Russel Garments Ltd.

20 April 2014

Building Observations

Typical column layout

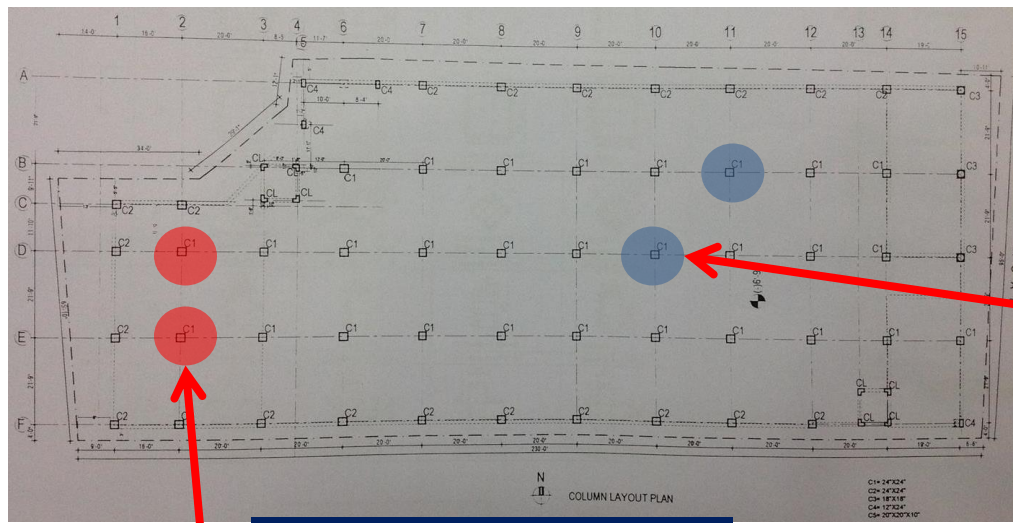
**Columns appear to be stressed in excess of
normal design limits**

Preliminary calculations indicate that working stress is at a high level for all columns.

A Detailed Engineering Assessment of the building is required (See attached Scope). Building engineer is to perform detailed calculations based on as constructed dimensions, loadings. Use material data from concrete tests to prove column size and in addition to the immediate actions noted in this report, if required:

- Reduce loads by vacating floors and removing undocumented structures, partition walls and floor finishes.
- Reinforce columns

Locations of cracking

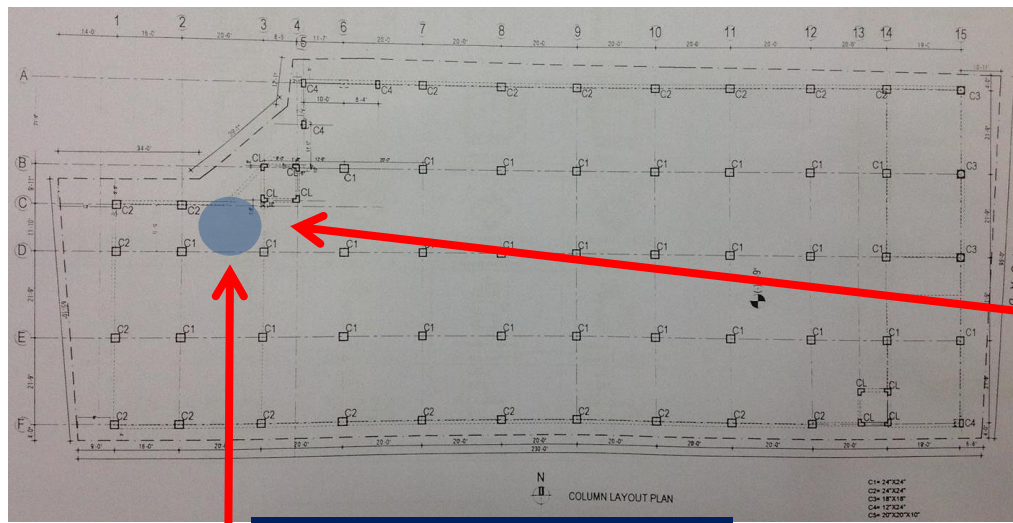
Cracks to be reviewed by removing floor finishes to investigate if they extend into structure.

There was a toilet nearby with heavy buildup – engineer to confirm that this has been allowed for in design.

Locations of cracking

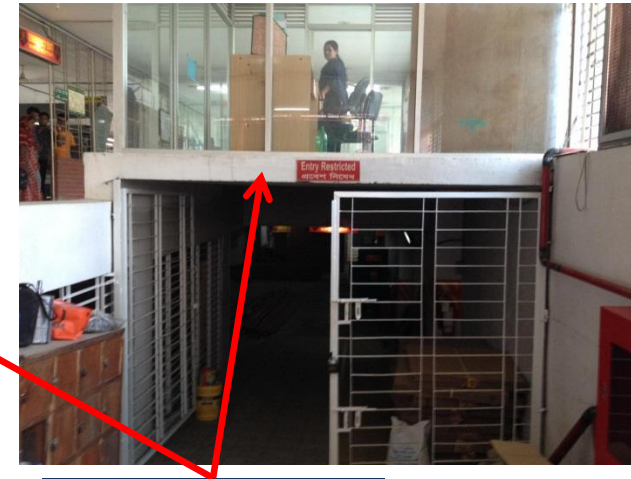
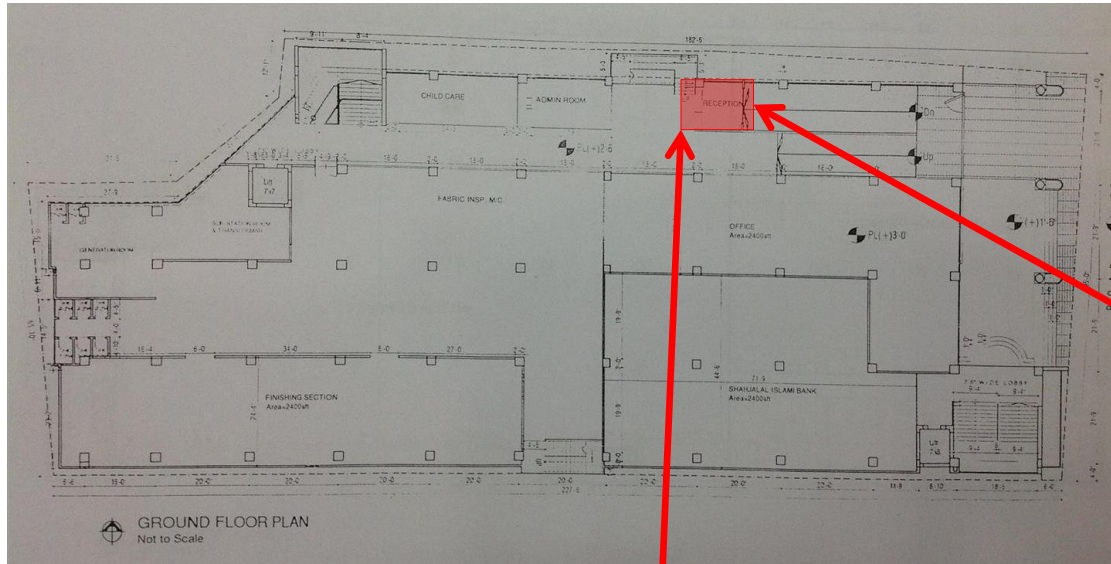
Cracks to be reviewed by removing floor finishes to investigate if they extend into structure.

Defects to ramp structure

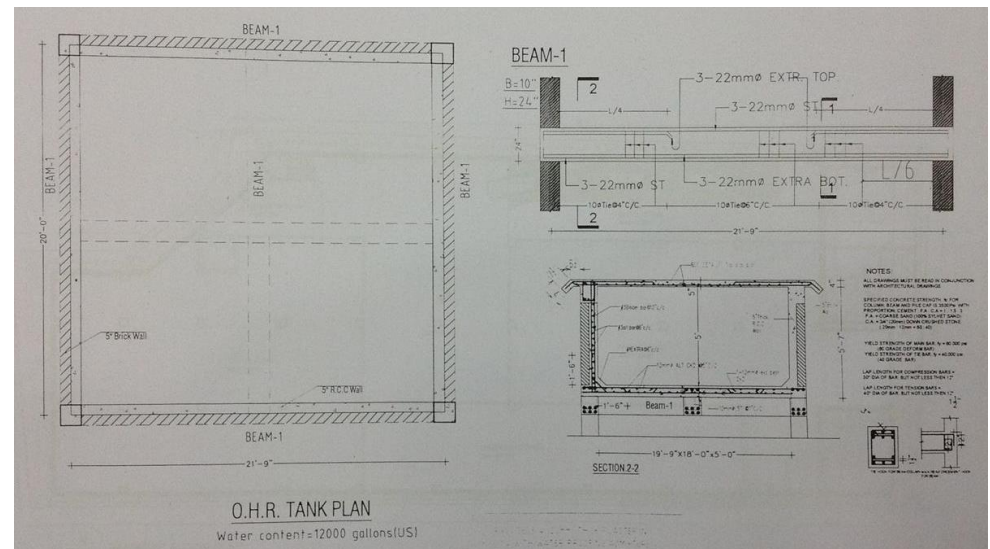
Load path for mezzanine structure over ramp is not logical and signs of distress in ground floor slab are evident.

Cracking to ground floor slab.

Column built off edge of ramp slab (support?)

18	Defects to ramp structure	Building engineer to review design of ramp structure, mezzanine floor and adjoining ground floor structure and design strengthening as required to support the codified design loading.	6-weeks
19	Defects to ramp structure	Implement strengthening specified by the building engineer.	6-months

East Elevation

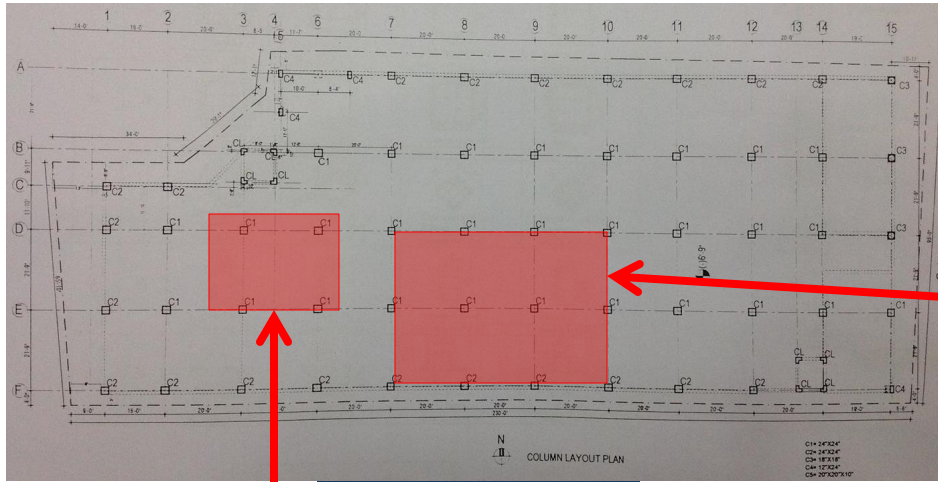
Uppermost floor not documented within the structural drawings provided.

No structural information suitable for construction was provided for any structure above the 9th floor. This includes the 10th floor slab, the columns above the 9th floor, the overhead water tank, the stair core over runs and the lift core over runs.

The permit drawings also did not account for the uppermost floor.

Localised areas of high loading

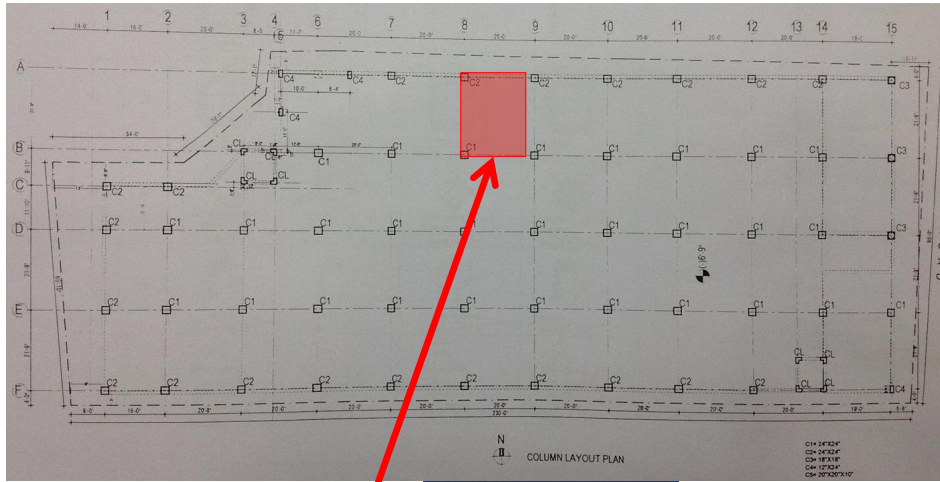
Uncontrolled stacking of materials.

Areas of high loading on suspended structure. Floor load management system incomplete as no loading plans or loading height limits displayed.

1st Floor Plan

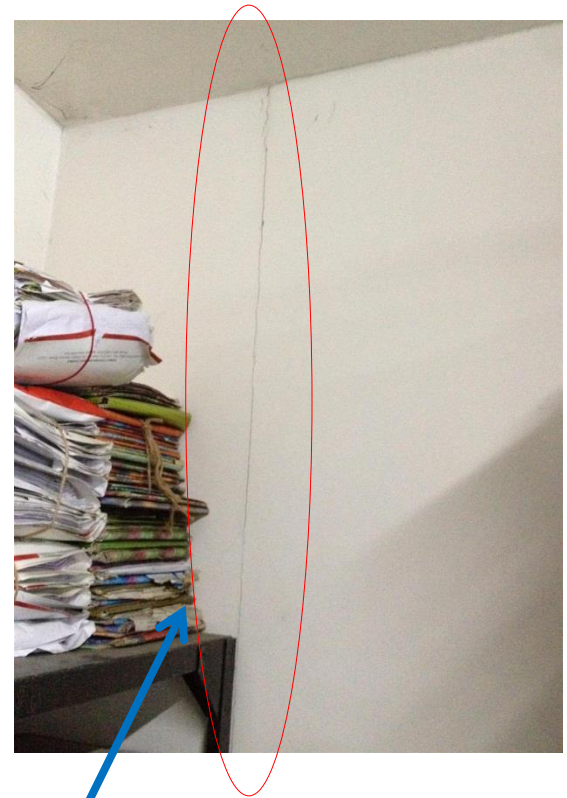
Uncontrolled stacking
of materials in bank
leading to cracking of
infill brickwork wall.

Columns susceptible to impact loading

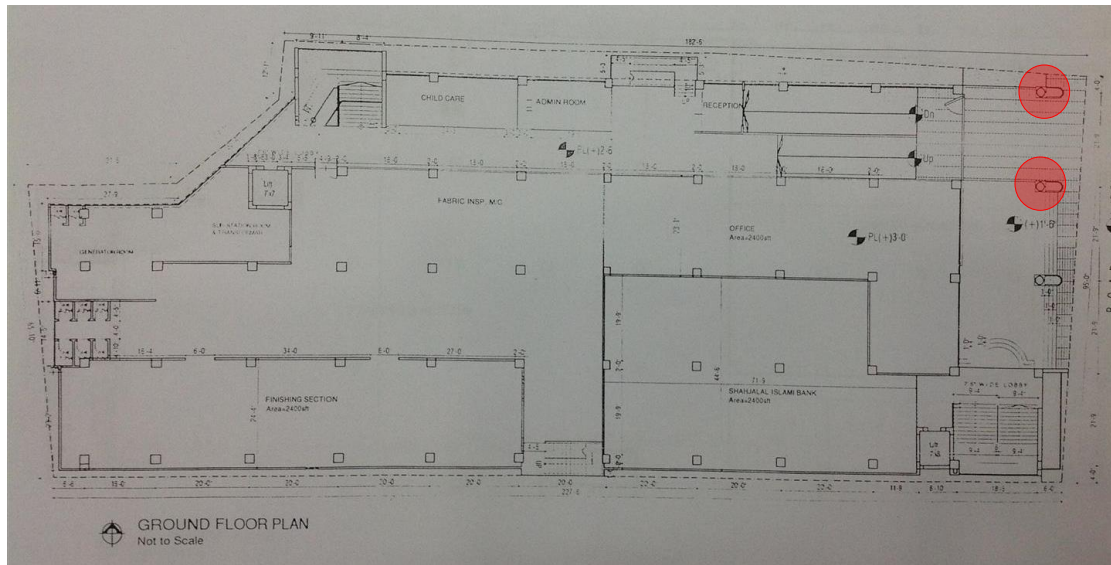
Columns at front entrance are susceptible to impact loading from vehicles.
